JLRTB02040NAS1
TECHNICAL BULLETIN
26 MAY 2020

Heated Tailgate Window Inoperative

MODEL:	MODEL YEAR:	VIN:	ASSEMBLY PLANT:
I-PACE (X590)	2019 Onwards	F60094 Onwards	Graz (Austria)

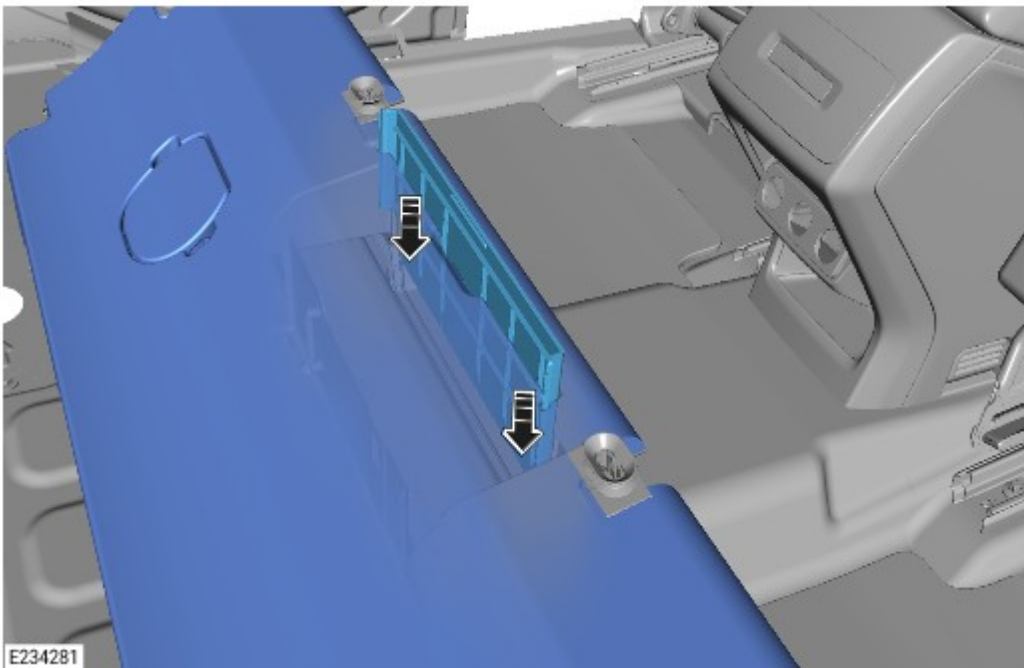
Remove and discard fuse F17 from the PJB.

- ■ Install the new 30A mini fuse in F17 of the PJB.
